Idaho Department of Environmental Quality Draft Final §401 Water Quality Certification

April 14, 2014

NPDES Permit Number(s): #ID-002659-0 Hayden Area Regional Sewer Board Wastewater Treatment Facility (HARSB)

Receiving Water Body: Spokane River

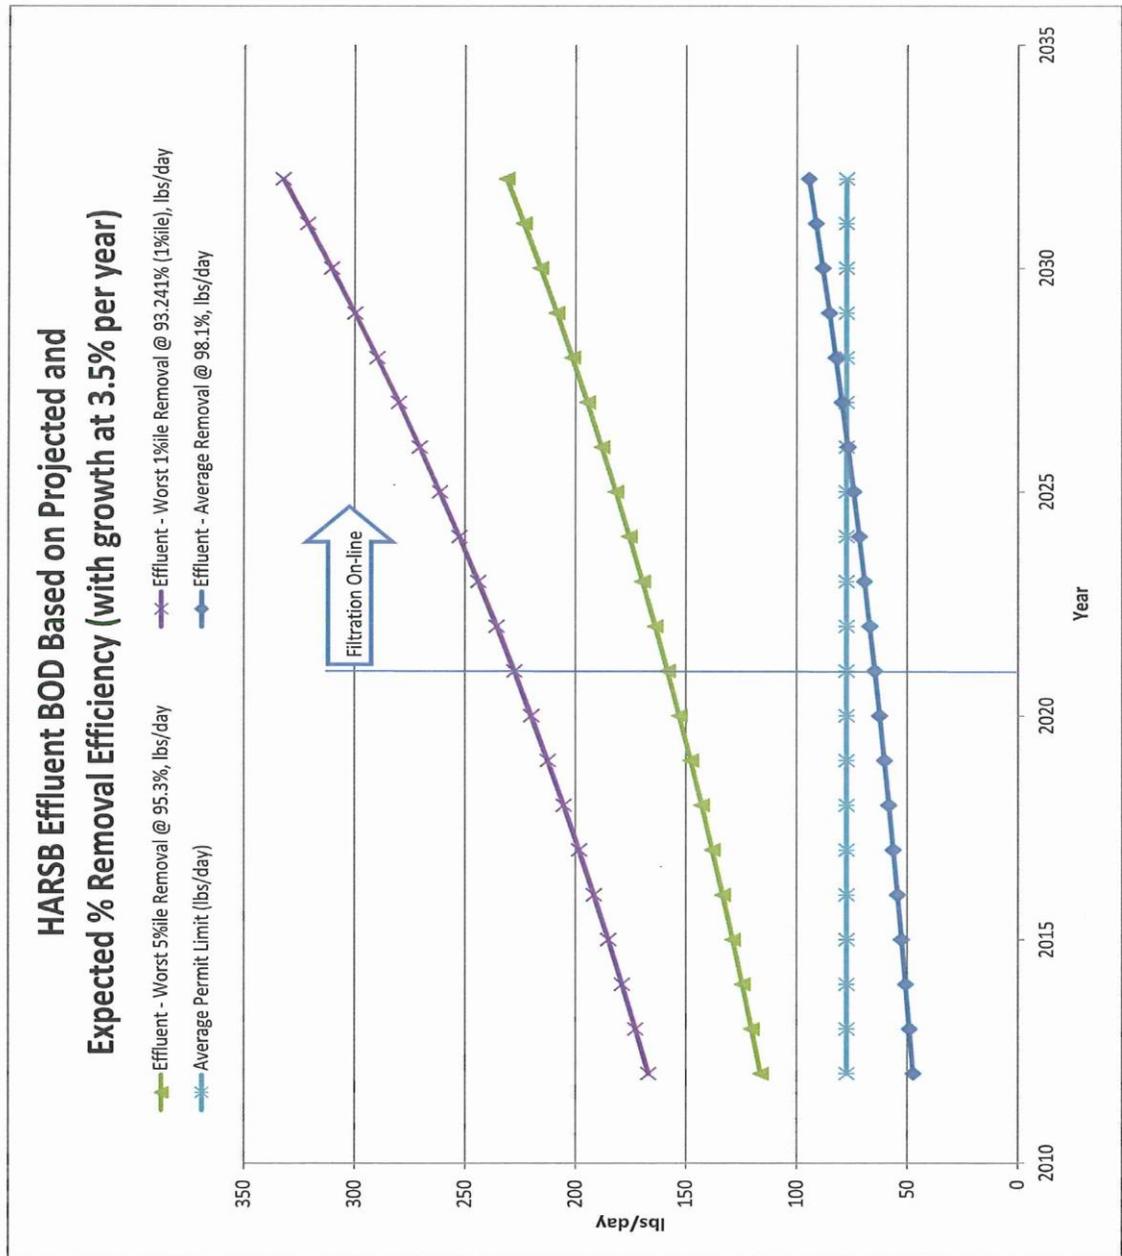
The HARSB facility has averaged about 98% BOD removal. The 98% BOD removal is due in large part to the plant operating 100% of the treatment facility while receiving about half of the design flow. The attached is a graph representing the BOD removal for the future growth factors. The 95% BOD removal graph line show that at the end of permit year eight, at 2021, a 162 lbs per day BOD loading. Our facility evaluation of BOD to CBOD ratio is very close to 1.0.

One additional factor to future HARSB BOD removals less than 99% is that the HARSB treatment plant oxidation ditches and clarifiers will be taken out of service to perform the upgrades to meet the final permit standards. We are asking for a compliance schedule for HARSB CBOD in consideration of excursions that will be beyond our control until the tertiary filtration is on line. It is everyone's intention that there will be no excursions that is why a CBOD limit equivalent to our current BOD limits will maintain current water quality but not subject the HARSB treatment facility to NPDES violations.

In summary, we are requesting the 401 Certification include a CBOB compliance schedule that runs concurrent with the phosphorus compliance schedule. CBOD limits should approximate current BOD limits.
